# Part IV of January 18, 2017 PZC Agenda Packet

TO: Planning & Zoning Commission  
FROM: Heather Valone, Village Planner  
THRU: Jeffery Stein, Deputy Village Administrator  
SUBJECT: Case 14-12 Donegal Excavating PUD  
DATE: January 4, 2017

Case No. 14-12  
Project Name Donegal Excavating

**Figure 1** All lots that combined make up the subject property.

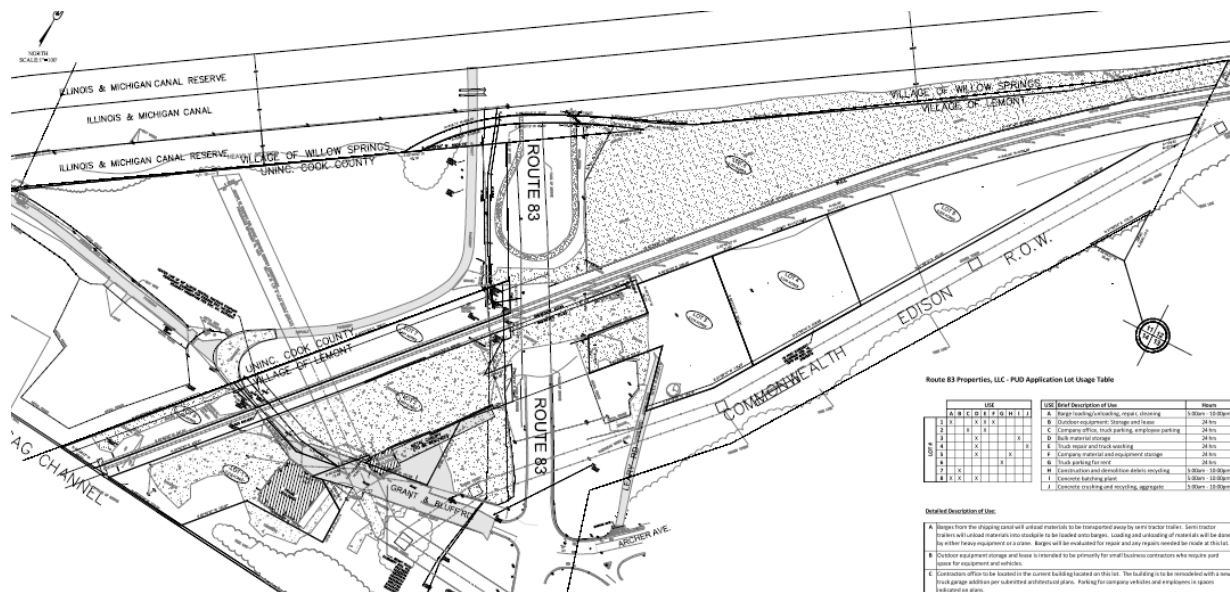
East of Route 83, south of the ROW, Lot 3 is proposed for a concrete batching plant. Lot 4 is proposed for a concrete crushing and screening plant. Lot 5 is proposed for a construction and demolition debris recycling (C&DD) facility. The easternmost part of Lot 5 is designated as the area for a stormwater detention facility. In addition to the uses detailed on the PUD site plan, the applicant has requested a list other variations from the UDO.

**LOT NUMBERS & USAGE PLAN**  
**ROUTE 83 PROPERTIES**

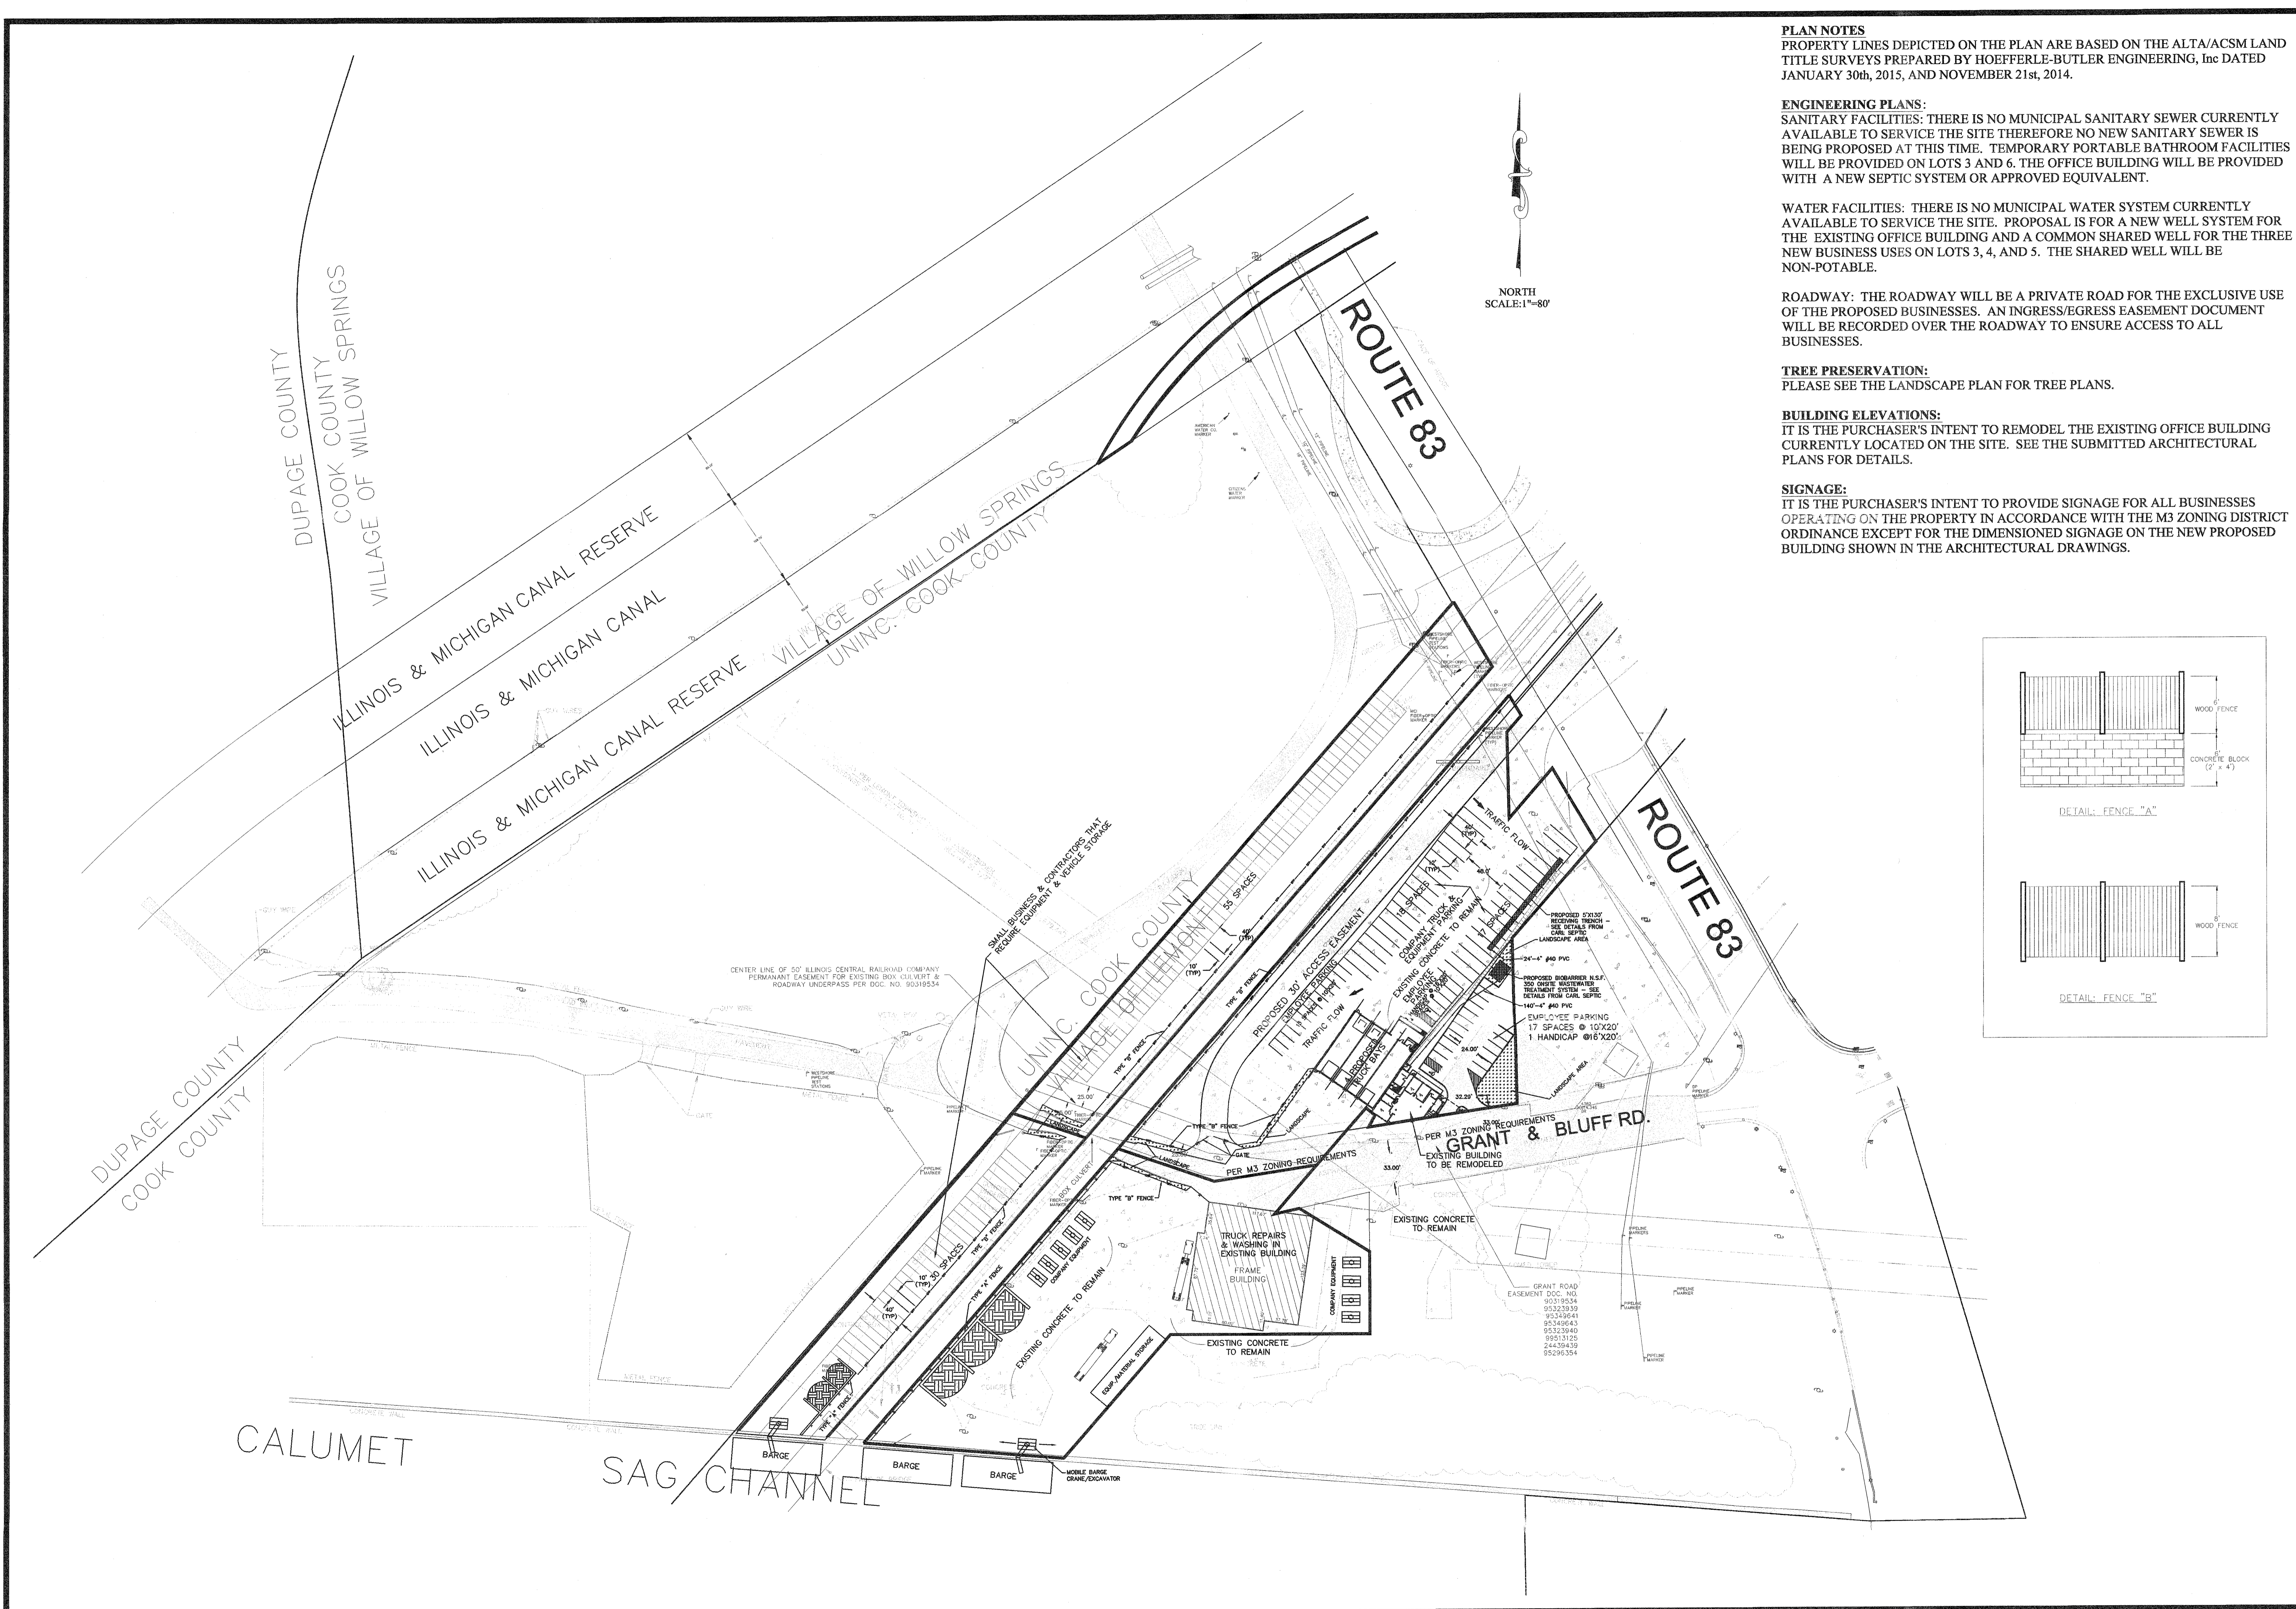
The traffic study indicates that the hours of operations for the facility are 5:00 am to 8:00 pm; however, the engineering plans indicate that the hours of operations for the C&DD, concrete recycling, etc. will be from 5:00 am to 10:00 pm. The staff is recommending operation hours of 7:00 am to 8:00 pm and update the submittals accordingly.

13. Revise the plans to limit hours of operation for the C&DD and any other noise generating machinery to 7:00 am to 8:00 pm.
14. Update the traffic study to include an analysis of the culvert access and safety under the rail road tracks. Additionally include an analysis of the queuing capability of Grant Rd.
